**The Empire District Electric Company
Kansas Corporation Commission
Docket No. 18-EPDE-184-PRE
Response to Staff's Eighth Set of Data Requests**

Response provided by: James McMahon
Title: Vice President, Energy Practice
Company Response Number: STAFF 8-73
Date of Response: March 1, 2018

Memorandum

Subject: Updated Analysis Results

40 Yr PVRR

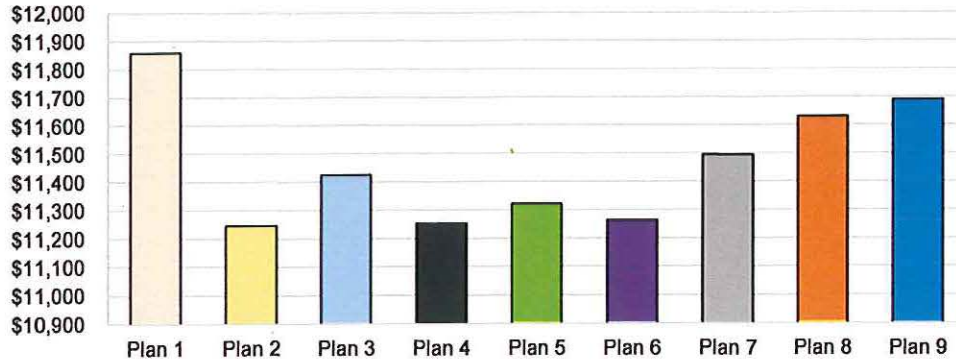
- Alternative Assumption with 40-year time horizon* – The nine original plans were evaluated over a 40-year time period in addition to the original 20-year and 30-year frameworks. In extending the period to 40 years, additional natural gas capacity was added in each plan after the wind projects came offline or as reserve margin requirements demanded. Although Plan 2 requires additional capital expenditures versus Plan 1 at the end of the 40-year time horizon to replace the retiring 800 MW wind capacity, the additional costs do not meaningfully impact the PVRR. Overall, the 40-year study confirms the same plan ordering as was shown in the 30-year study, which is summarized below.

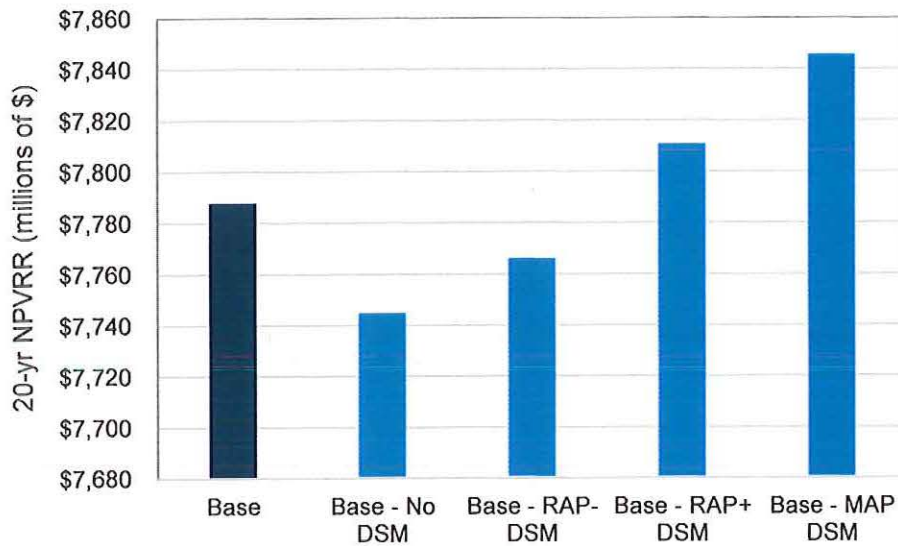
- Additional Plans with Different DSM Assumptions** – Updated DSM plans were developed and evaluated against Plan 2 from the GFSA. Plan 2 from the GFSA included RAP DSM. The new plans were developed with No DSM, RAP-, RAP+ and MAP. In all four alternate DSM plans, 800 MW of Low-LCOE wind was still built, as in Plan 2 (the Base Plan). The new plans resulted in slight changes in new build timing. Adding more DSM increased the relative cost of Plan 2 by up to \$58M on a 20-year NPV basis (vs. MAP). Removing DSM decreased the relative cost of Plan 2 by up to \$43M on a 20-year NPV basis (No DSM). These results are shown below, with the relationship the same on the 30-year NPV basis.

20-year NPV

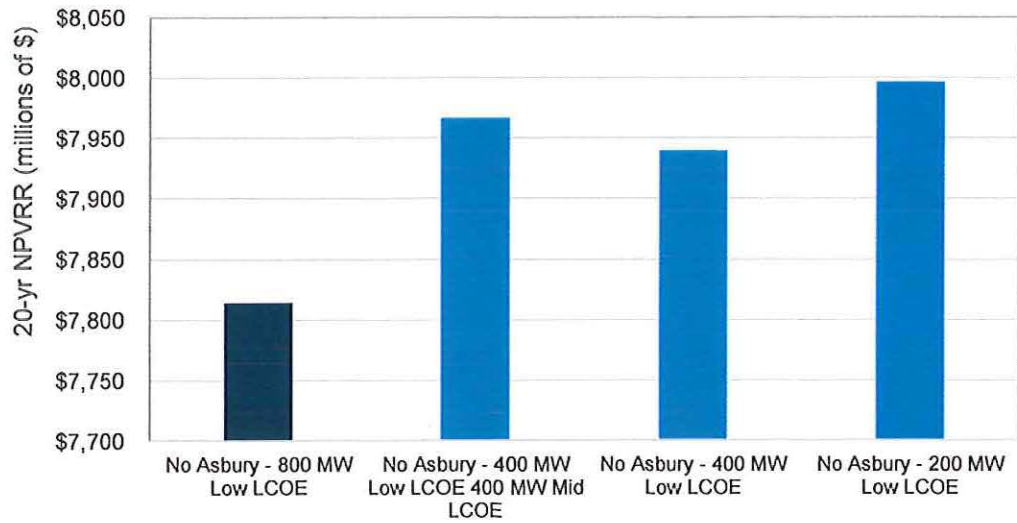
- It should be noted that the relative cost impacts varied across plans for the 20-year and 30-year time horizon, as the performance of mid-LCOE improves over time as market prices are expected to increase. This is shown below.
